SERVICE BULLETIN No. 292 72 2218

Version: B

Reason for update: SB extension to ARRIEL 2 L2 variant.

Subject:
Module M05 - Replacement of the front and rear bearings of the intermediate gear.
Modification TU 218.

1. GENERAL

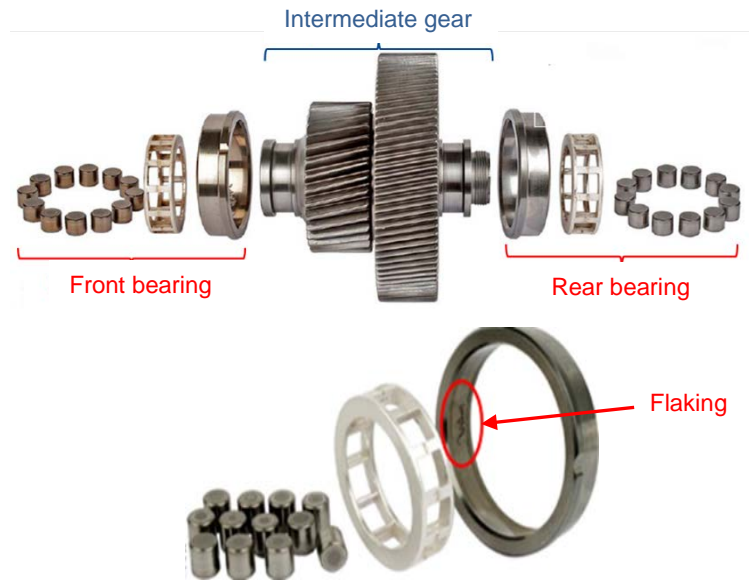
Investigations of modules M05 removed from ARRIEL 2 engines after chip detection, predominantly show flaking from front and rear bearings of the intermediate gear.

Modification TU 218 introduces a change in the component material of the two bearings in order to improve their mechanical strength.
